Adaptive reuse of
Existing Building for

Reflections
Contracting, LLC

Proposed
Elevations

A-2.03

1 NORTH ELEVATION ~ PROPOSED
SCALE 1/4"=1'-0"

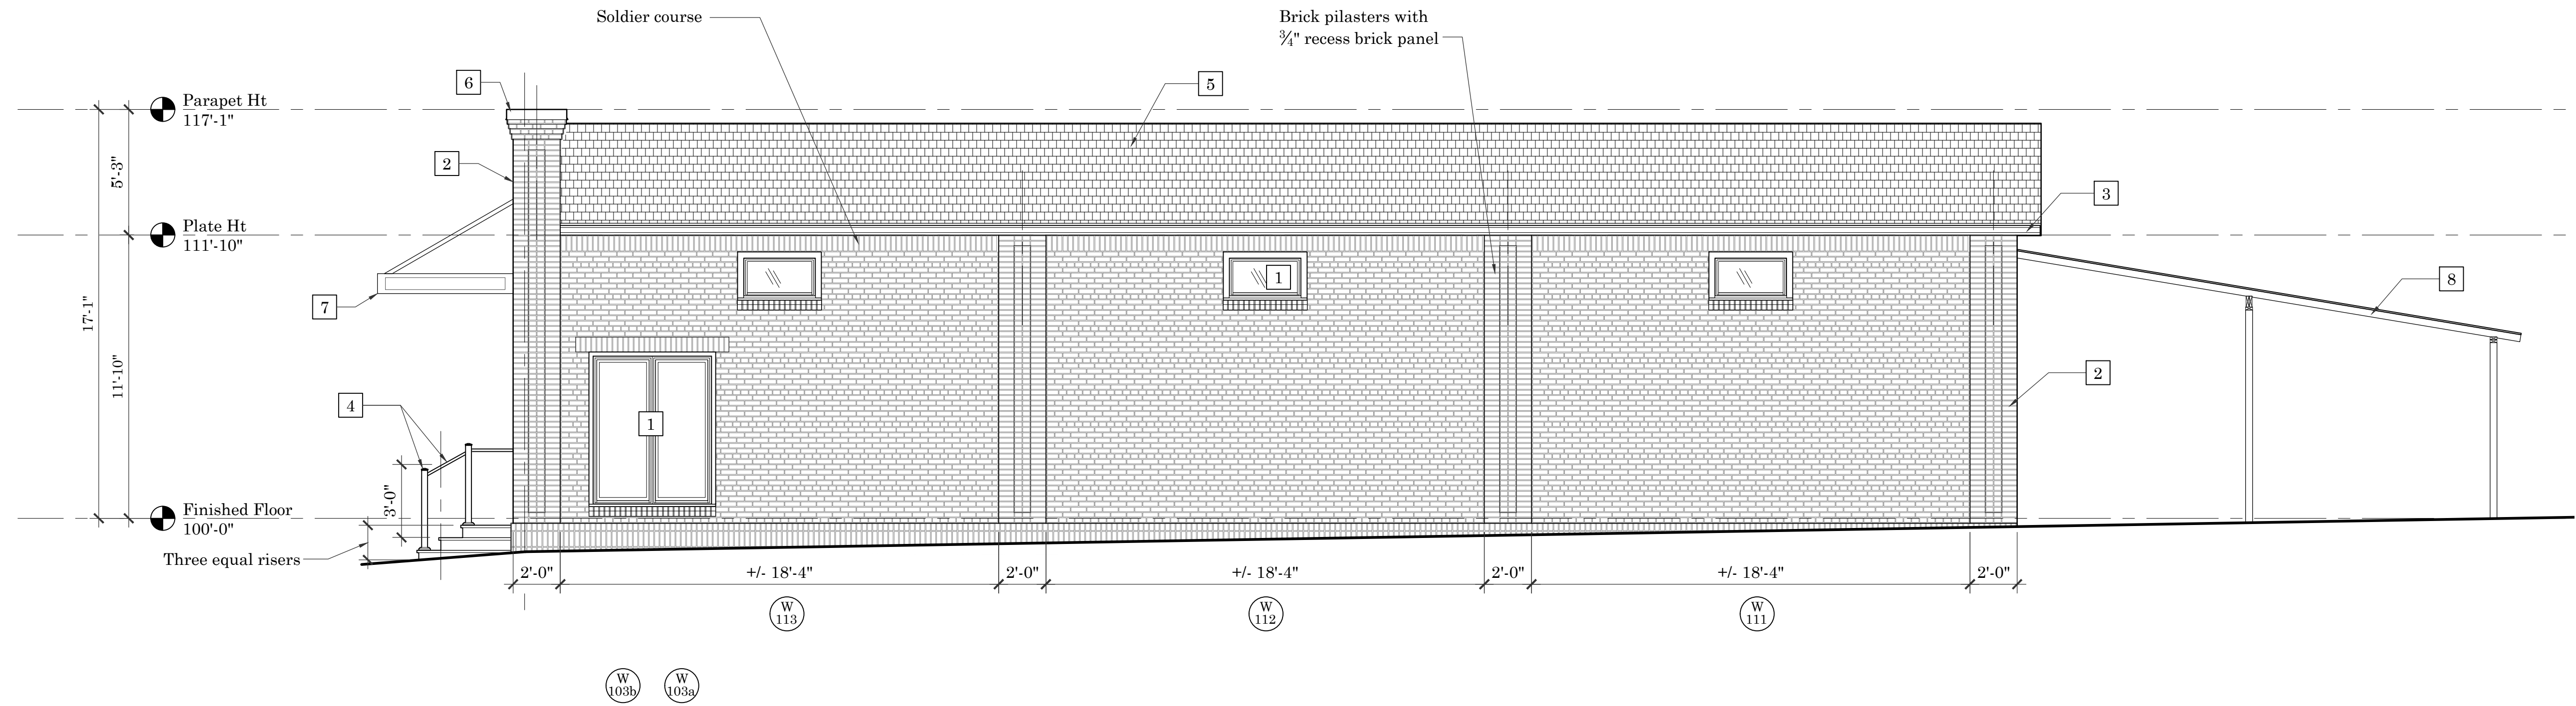
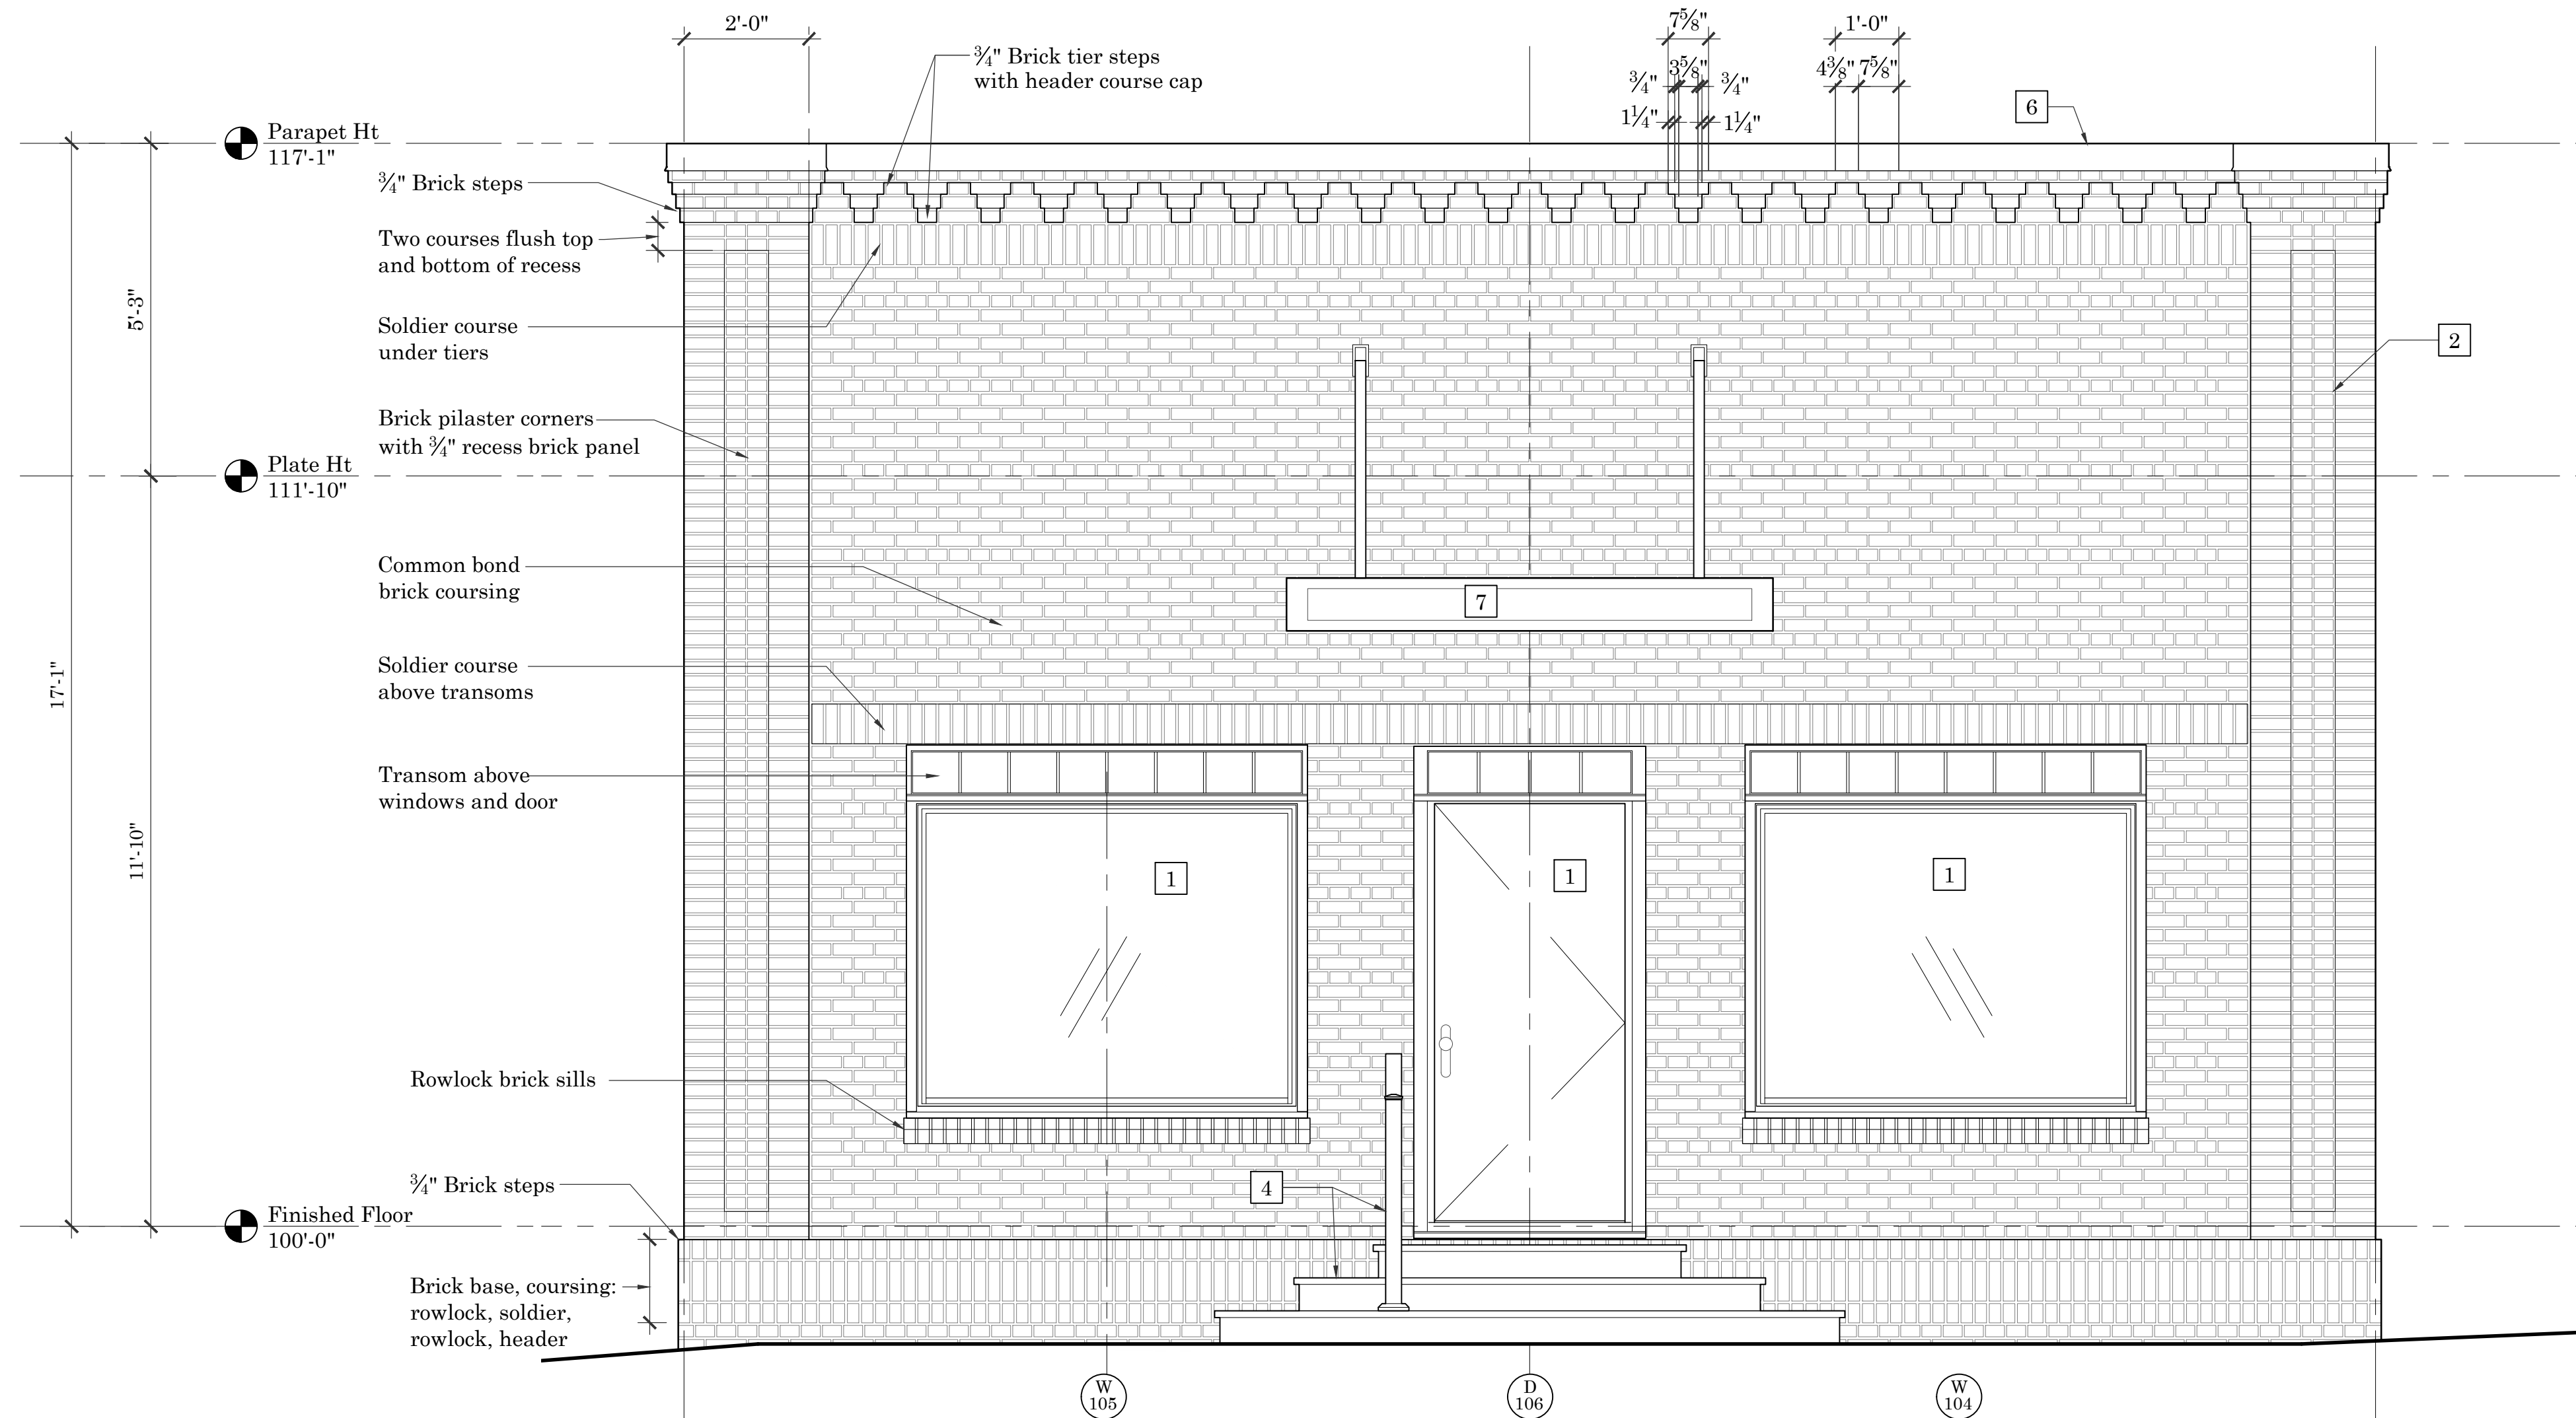
Elevations this sheet revised to incorporate plan layout changes shown on Sheet A~1.03 and to reflect the change from siding to anchored masonry veneer.

Elevations this sheet revised to reflect proposed masonry detailing for Planning Commission review.
